MIL-C-13516E
AMENDMENT 5
24 February 1992
SUPERSEDING
AMENDMENT 4
26 August 1991

MILITARY SPECIFICATION

CIRCUIT BREAKERS, MANUAL AND
AUTOMATIC (28 VOLTS DC)

FIGURE 2b. Endurance test.

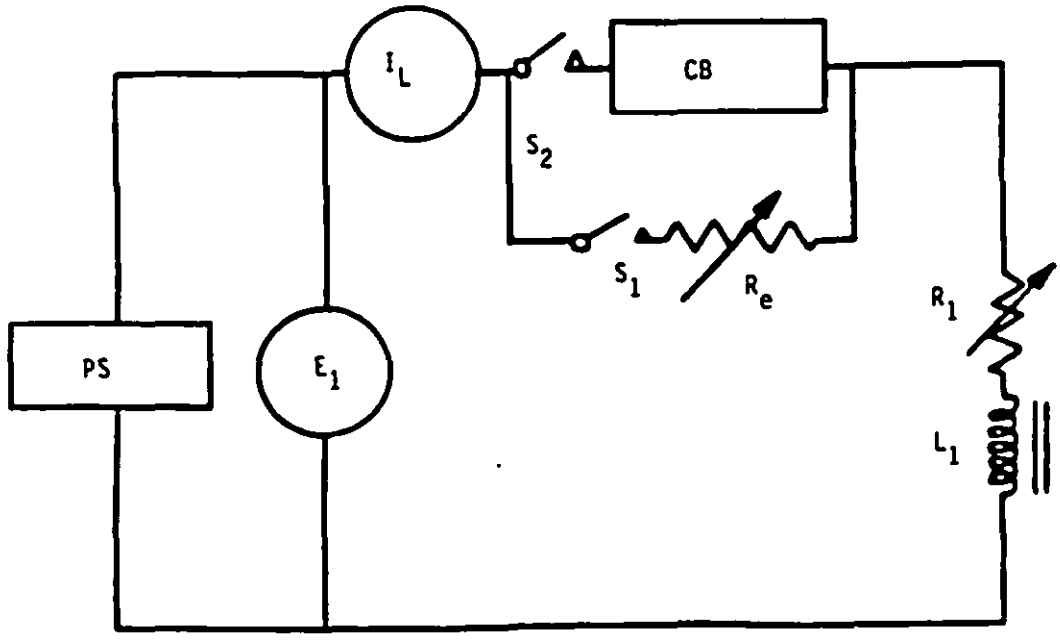
Add new figure:

4.6.9.2 Alternate B. The circuit breaker shall be connected as shown in figure 2b. R_1 shall be adjusted to give the specified current. L_1 shall be an inductor conforming to type I, MIL-I-81023. When it is necessary to parallel inductors to achieve specified circuit breaker tests currents, paralleling shall be in accordance with MIL-I-81023."
